Access Compliance Report

Public Rights-of-Way

Intersection ID: 49930	Main Street: PAXTON_RUN_RD	Cross Street: CHAMBERLIN_RD	Location: NE
ADA ID: D32F827A11B3	Ramp Type: BlendTrans1	Initial Pass/Fail: Pass	Overall Compliance: No
Severity Score: 7.5			
Codes/Mitigation Info/Possible Solution		Field Measurements/Component Compliance

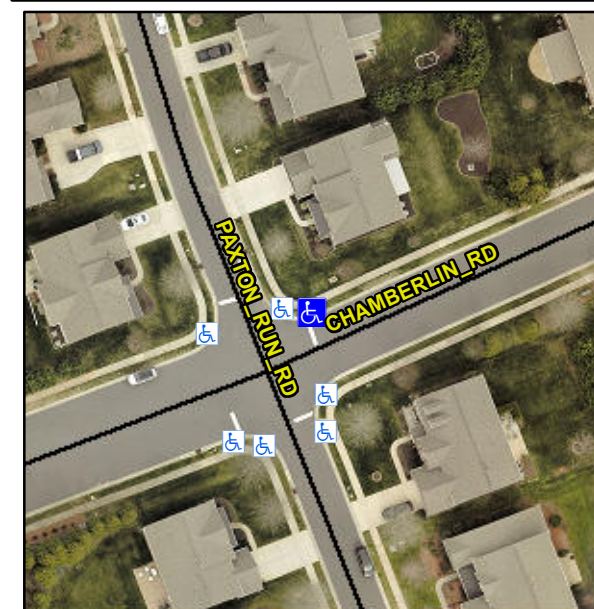
Not Found, R304.2.1, R304.2.2-Perp, R304.3.2-Para, R305.2, R302.7.2

Remove & Replace Curb Ramp With Two New Directional Ramps or Equivalent.
